## APPENDIX 19

PROPOSED CONCEPT

CARINE GLADES TAVERN – REPORT & PROPOSAL LODGED ON 7  
DECEMBER

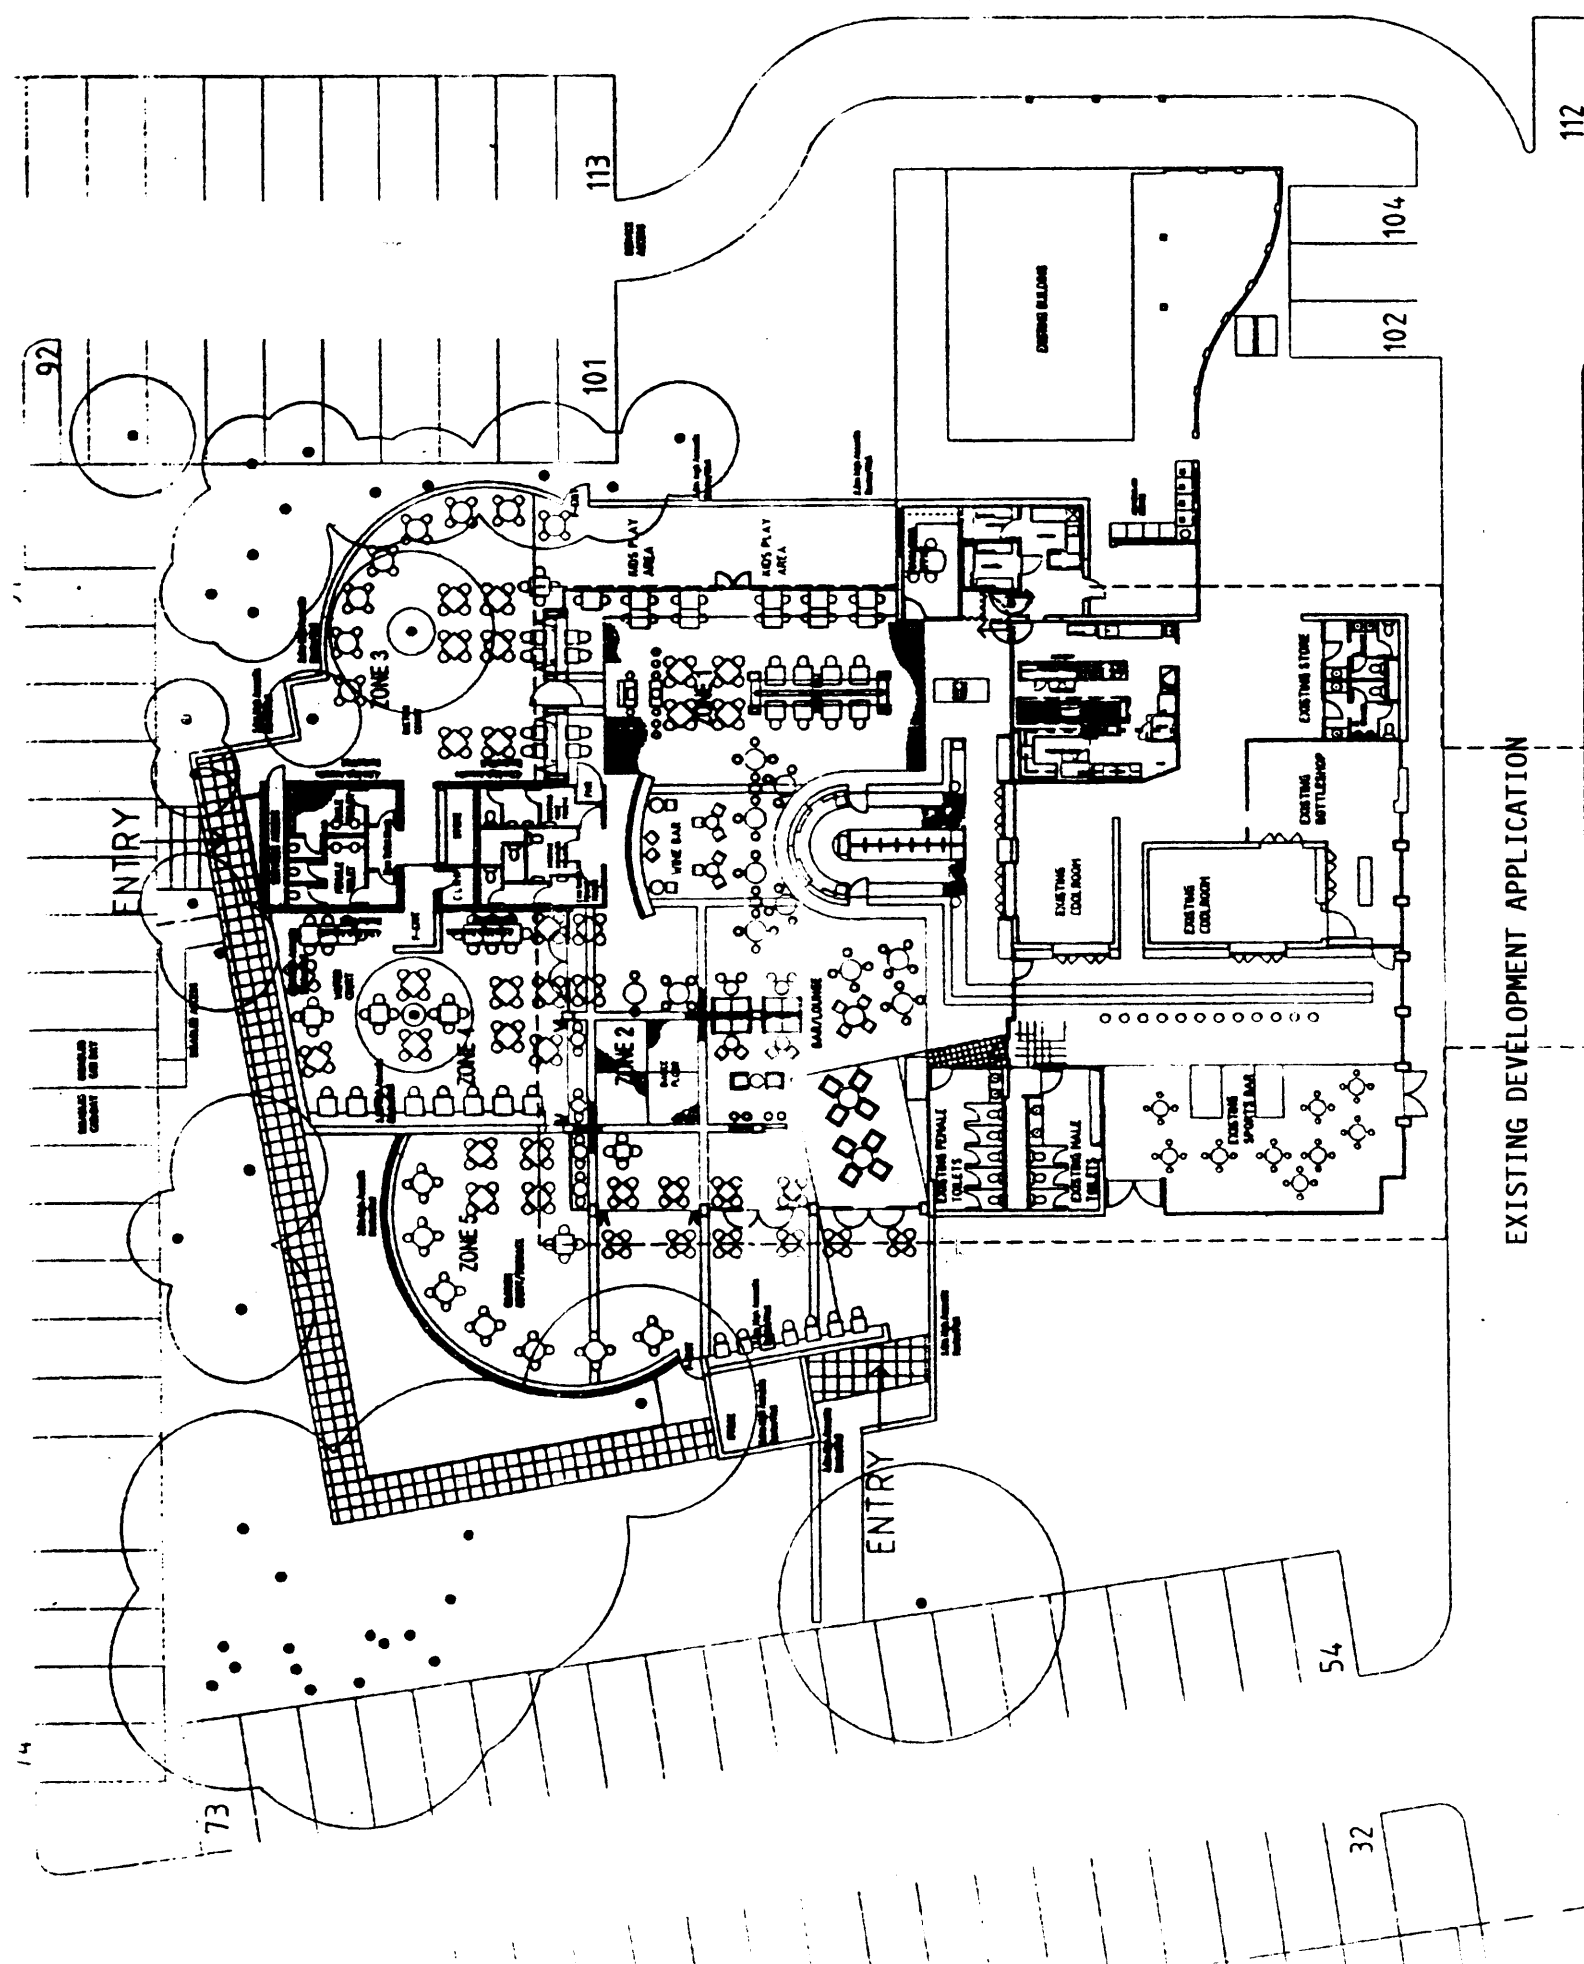
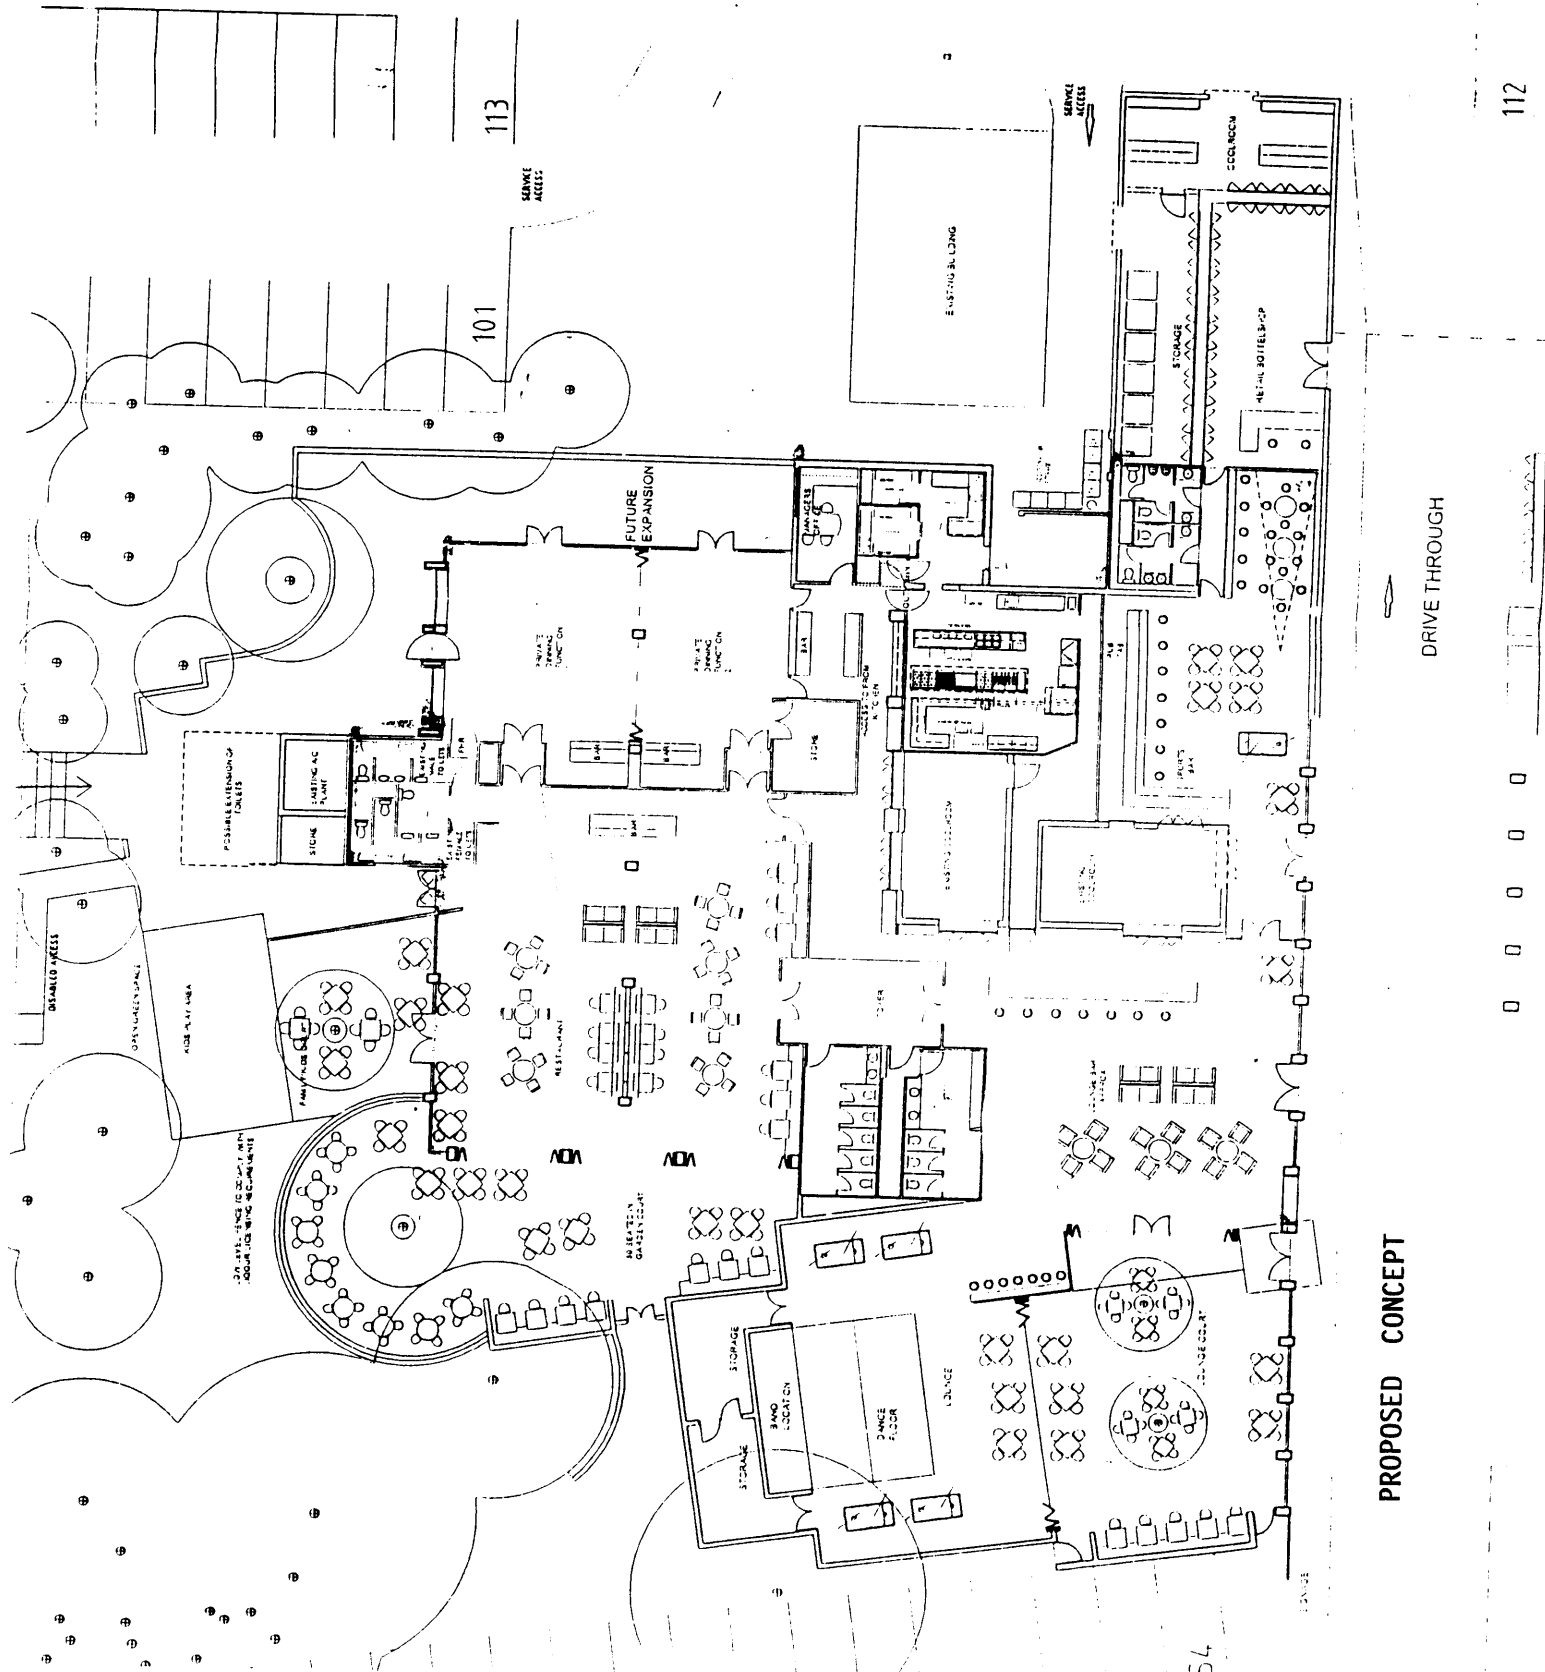
Initially, I should point out that the notional redesign appears to be very positive as it foreshadows the relocation of the major al fresco area from the North and East side of the development to the West. This is a positive move in terms of reducing potential impacts on neighbours.

- ☐ issues for consideration include
- ☐ break out noise through concertina doors
- ☐ break out noise through building structure (critically the roof), and insulation of band area.
- ☐ location of plant rooms, air conditioning installation, and bin service areas
- ☐ capacity of al fresco areas (although notionally this looks to be much improved on the earlier proposals)
- ☐ monitoring devices and strategies need to be developed

- ☐ building occupancy needs to be verified by checking detailed design, seating and standing areas etc
- ☐ scaled plans need to be lodged to provide surety as to size and likely occupancy of areas
- ☐ the strategy for building occupancy is a key factor, and your proposal to address this aspect should be detailed.

- ☐ complete site plans need to be lodged showing parking allocation
- ☐ parking demand will need to be re-checked. The rechecking need is caused by the increase in floor space proposed and the suggested reduced patronage levels proposed.
- ☐ Manoeuvring and access arrangements for service vehicles will require checking to ensure suit
